## **AQUIND INTERCONNECTOR**

### Design and Access Statement

Document Ref: 5.5

DATE: ~~14 NOVEMBER 2019~~ 6 OCTOBER 2020

Plate 4.1- Green panels and curved roofs

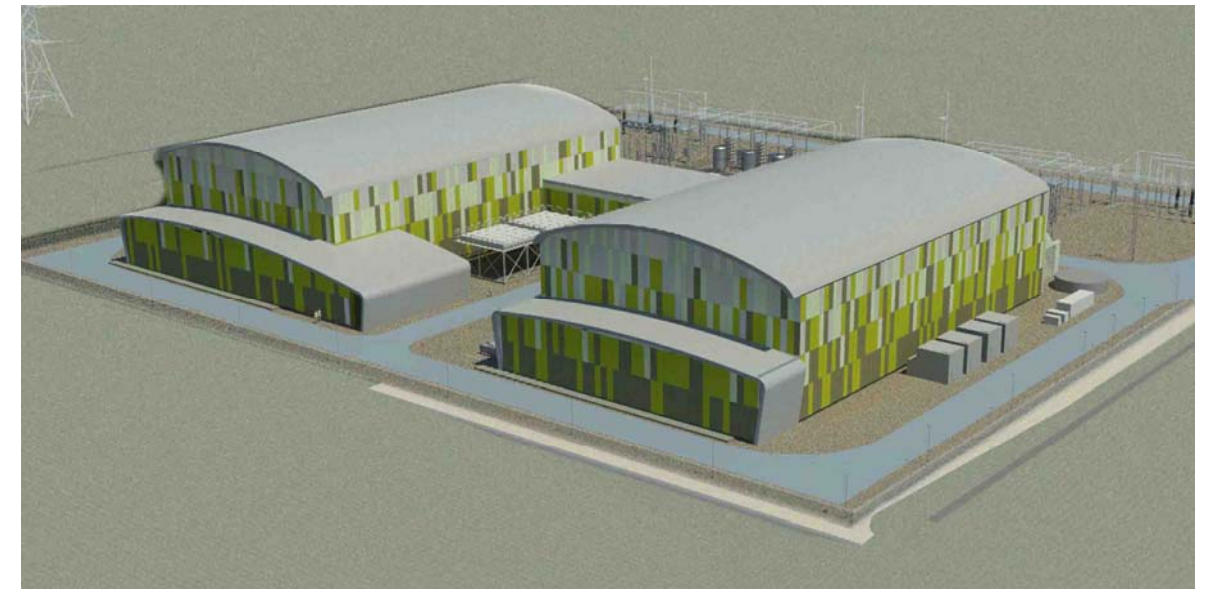
- **Comment:** Should the building be concealed or celebrated?
- **Response:** This was a concept that was proposed by EHDC, but other attendees expressed a preference for concealment. The alternatives were debated and it was agreed that prominent curved roofs (Plate 4.1) would be discounted.

**Plate 4.3 – Vertically arranged green cladding**

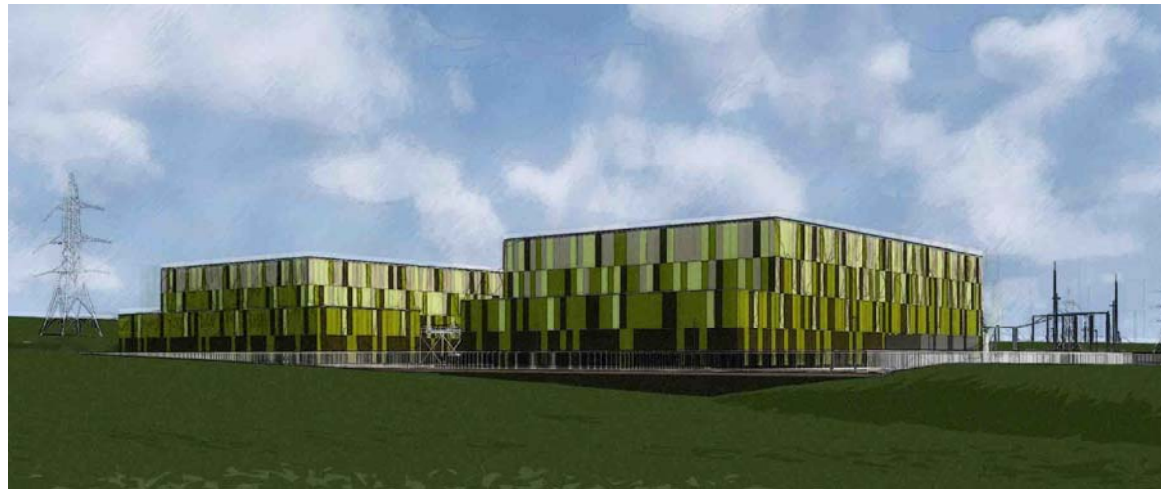
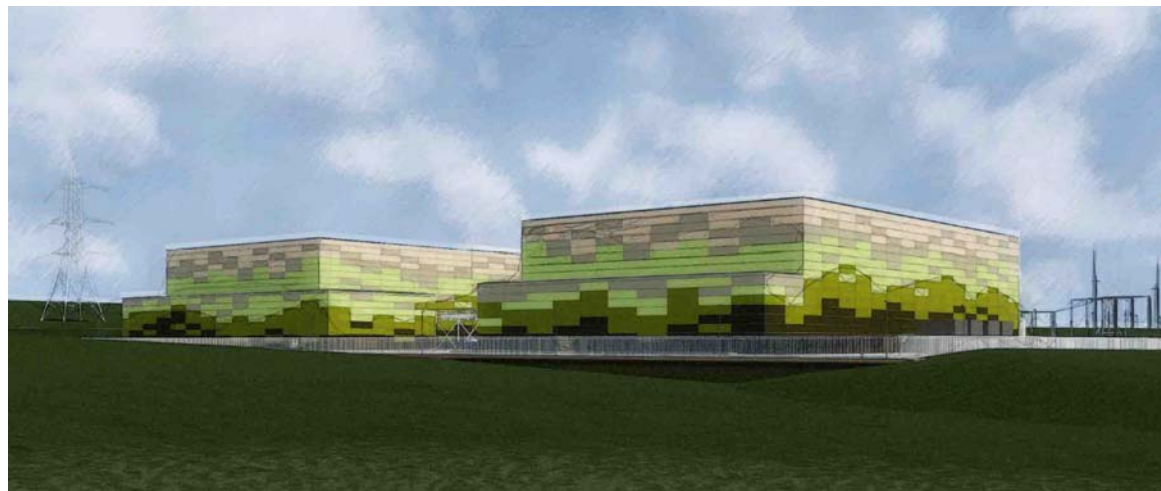
4.3.3.2. The site constraints were highlighted and discussed and three design options were explained in more detail. Options one and two both used rich green cladding arranged vertically and horizontally in order to blend into the landscape, with the third option being a darker option with a stronger architectural character. The first two options therefore sought to soften the building while the third option sought to celebrate the building. (Plates 4.3; 4.4 & 4.5)

- **Comment:** (WCC) Why are vertical rather than horizontal bands being used?
- **Response:** Vertical bands were selected as Architects had worked on buildings of similar scale. EHDC commented that they had seen the successful application on a number of projects with vertical bands.

- **Comment:** (WCC) Should the size of band widths be wider to reflect an “honesty” in the size of a large scale building?
- **Response:** Band widths could be varied and looked at, in option development.

- **Comment:** (WCC) Could timber be used to replicate some of the barns within the vicinity?
- **Response:** Due to operational requirements wooden materials are not acceptable within a live converter station site.
